16 Wildflower Lot #2

SEPTIC SYSTEM DESIGN PLAN FOR INTEGRITY BUILDERS
 MAP 2 LOT 21D 167 WILDFLOWER DRIVE
 AMHERST, MA.

Plan: 16 Wild Flower Dr. Designed by: Alan Weiss

CHECK LIST FOR SEPTIC PLANS

SEPTIC SYSTEM DESIGN PLAN FOR INTEGRITY BUILDERS
 MAP 2 LOT 21D 16? WILDFLOWER DRIVE
 AMHERST, MA.

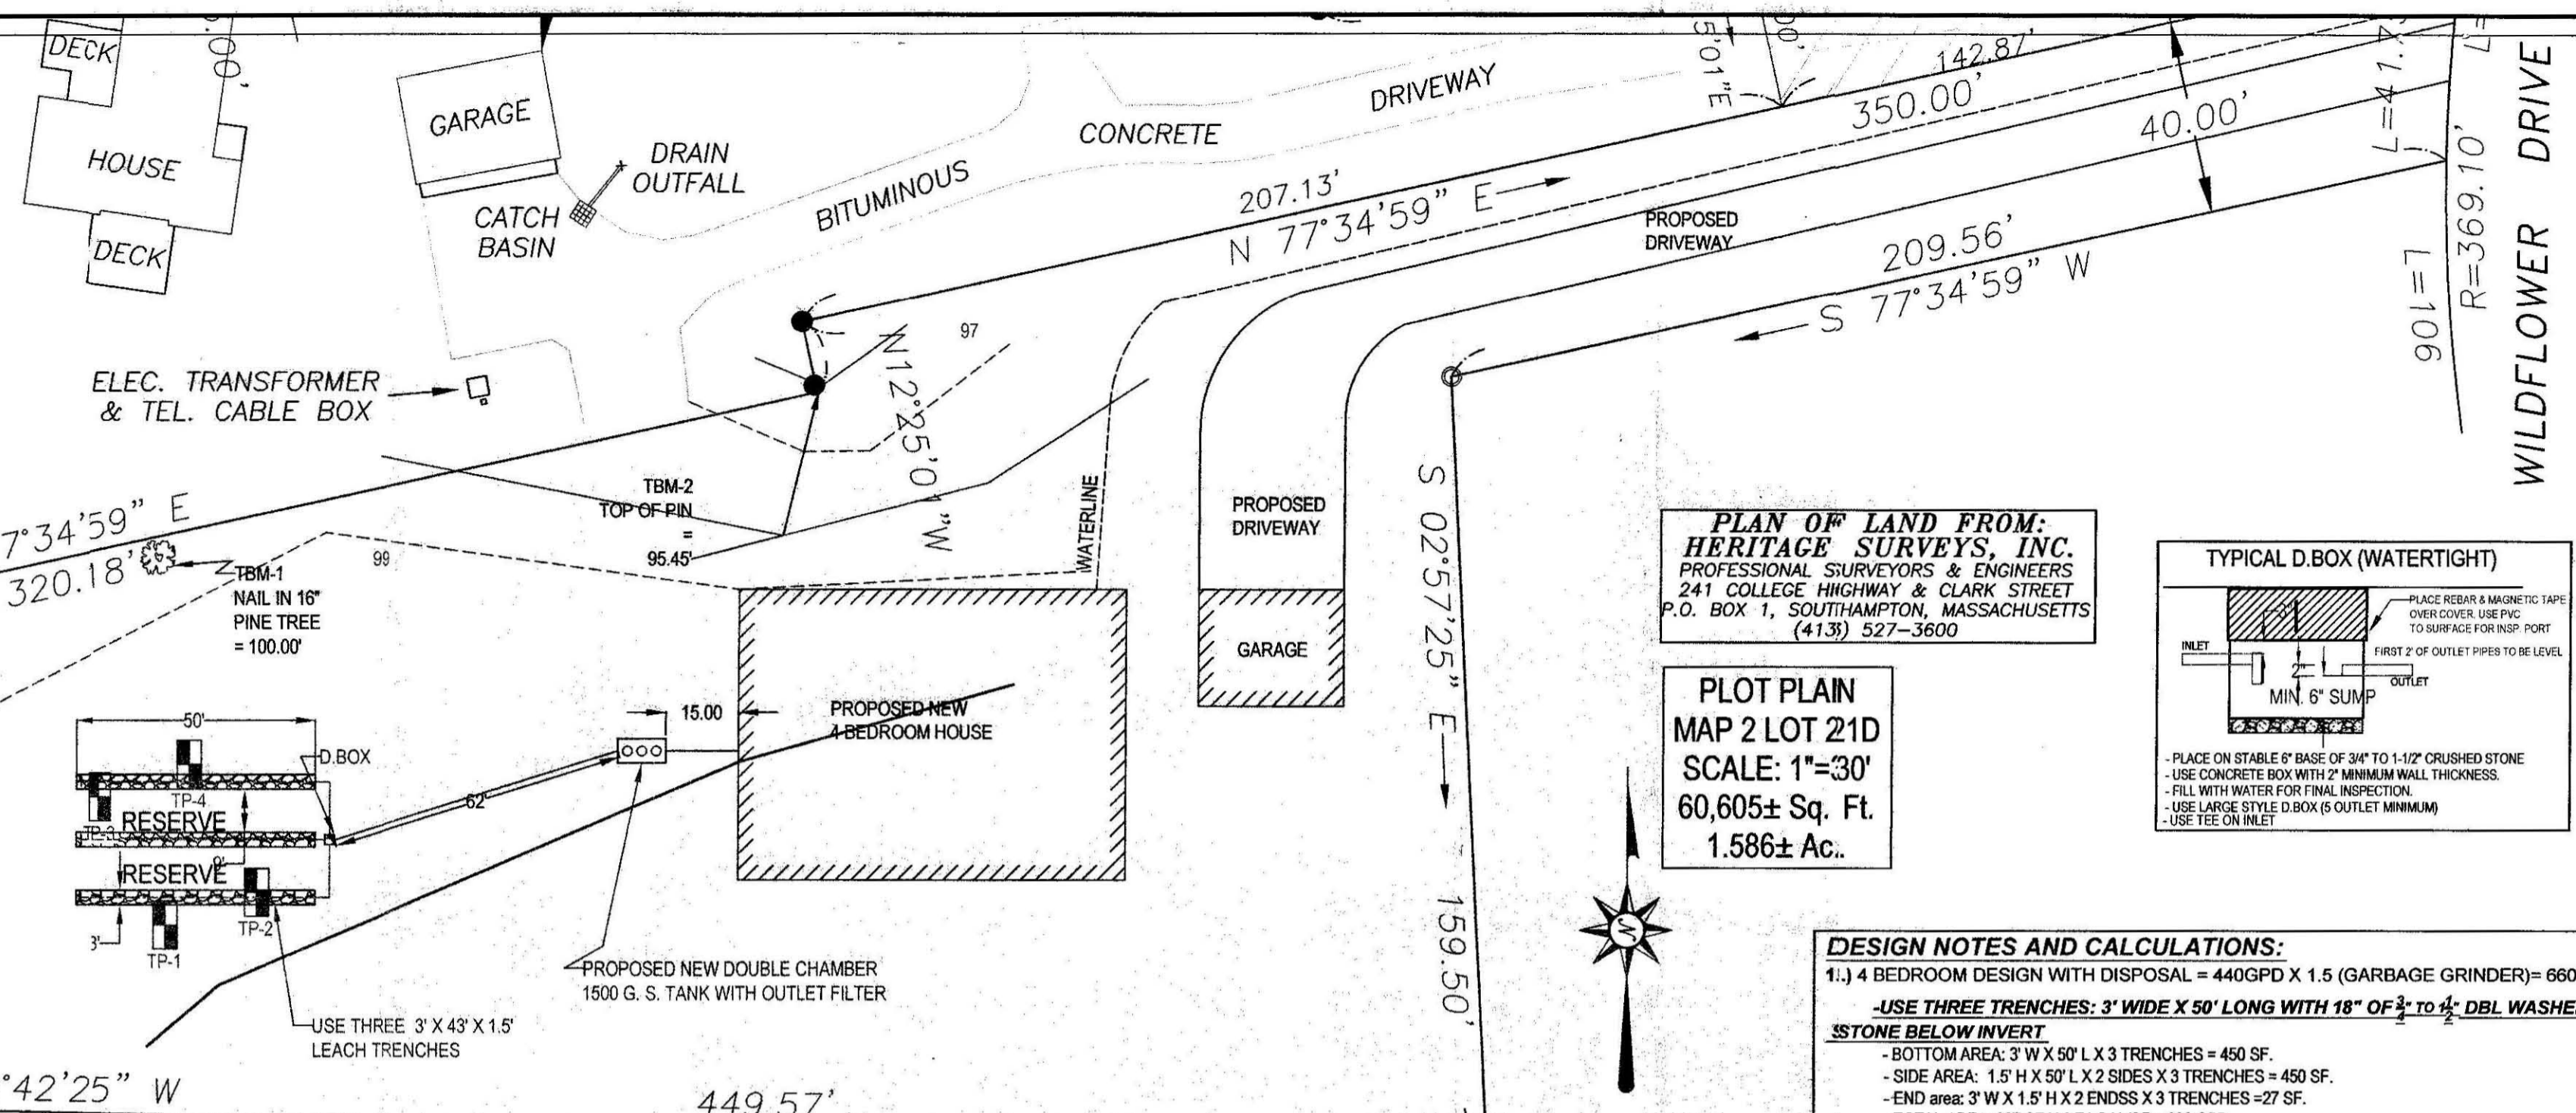
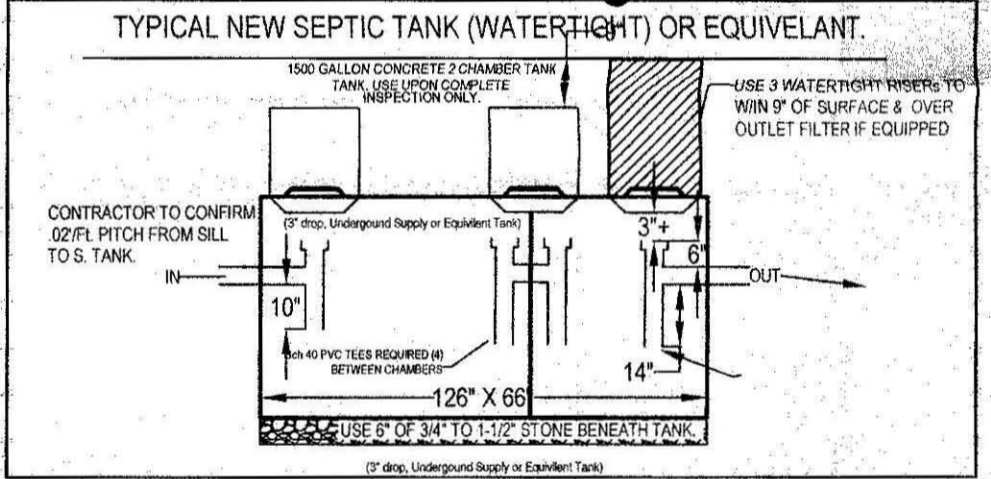
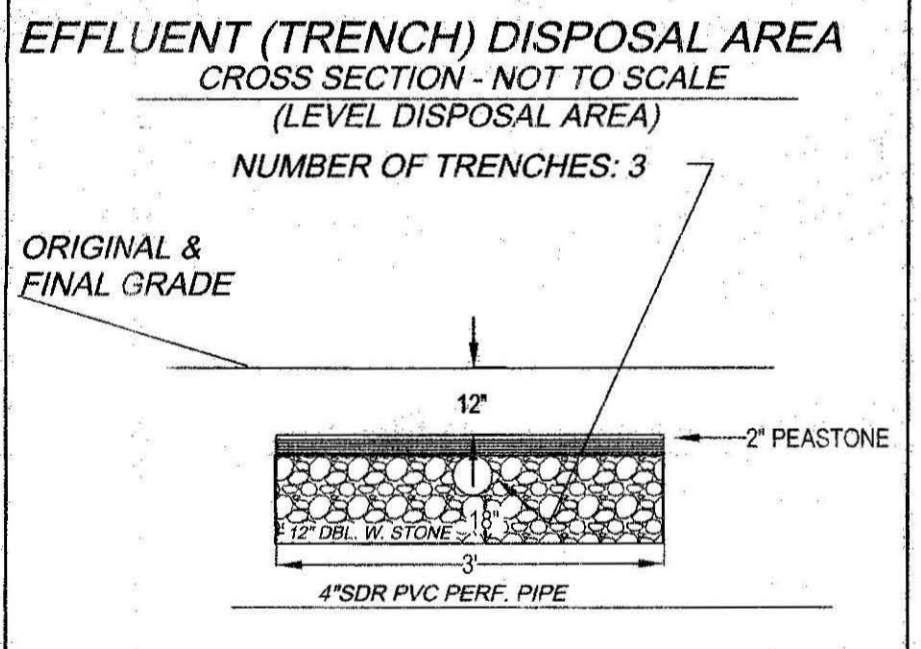
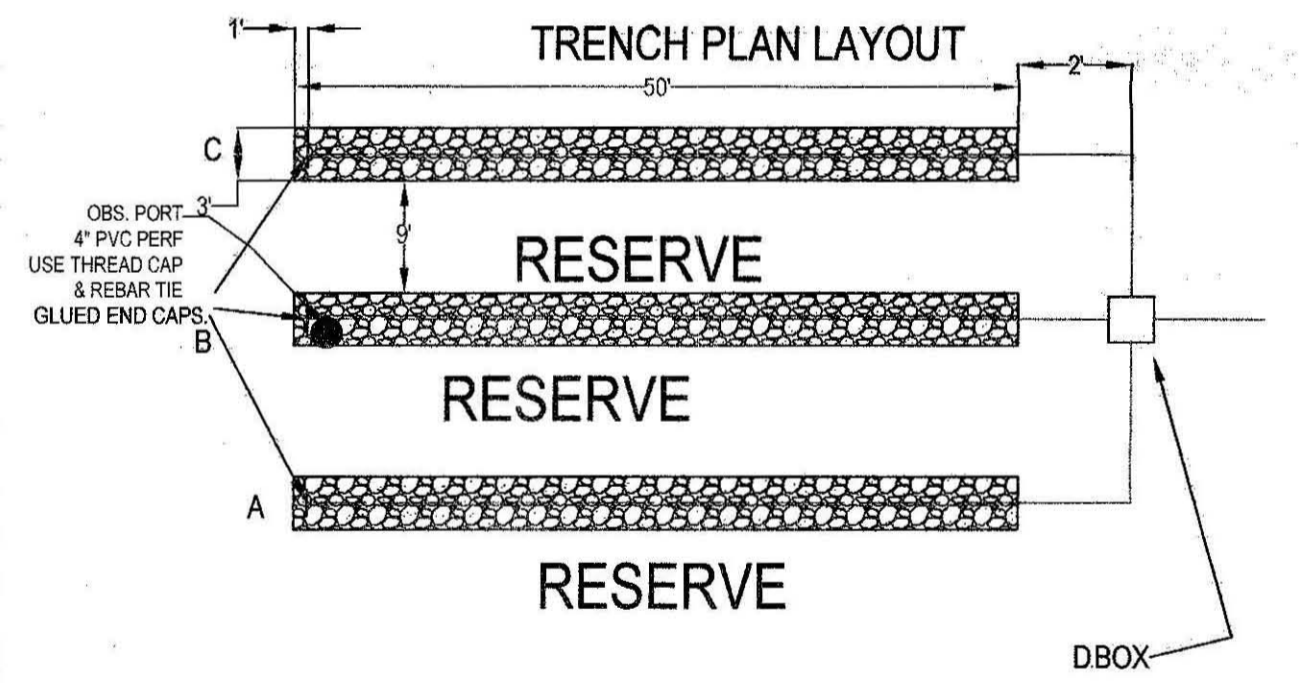
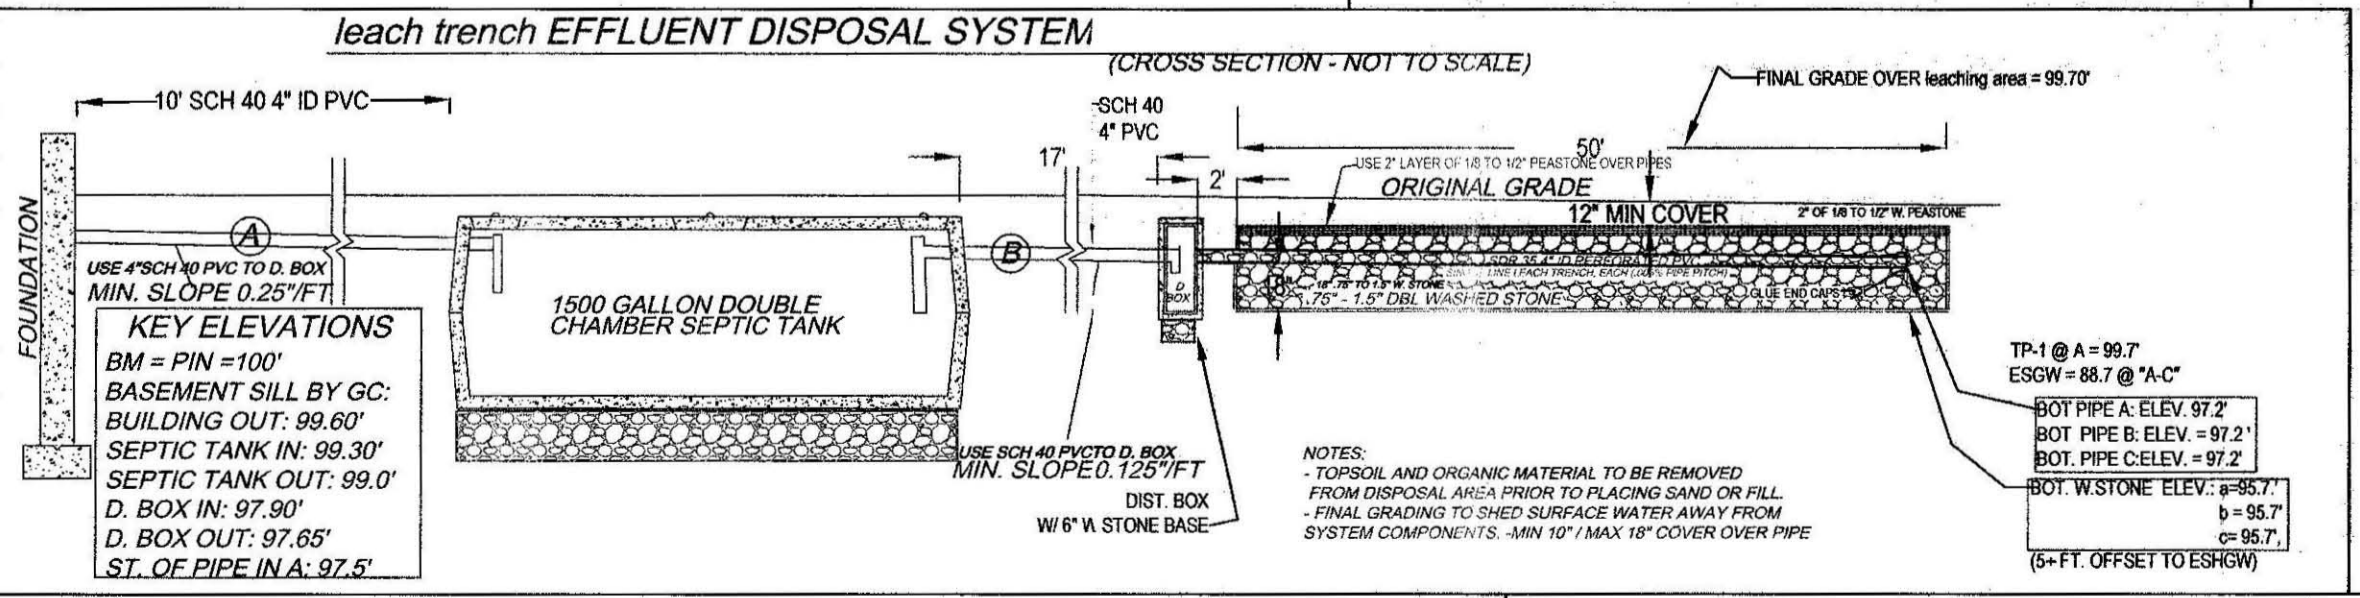
Risers 6" of surface on tanks.

Typo 12" of over dist. pipes should be changed
to 18" of double washed stone.Renewed
to
Alan
will be
on
As-built
11-10-08
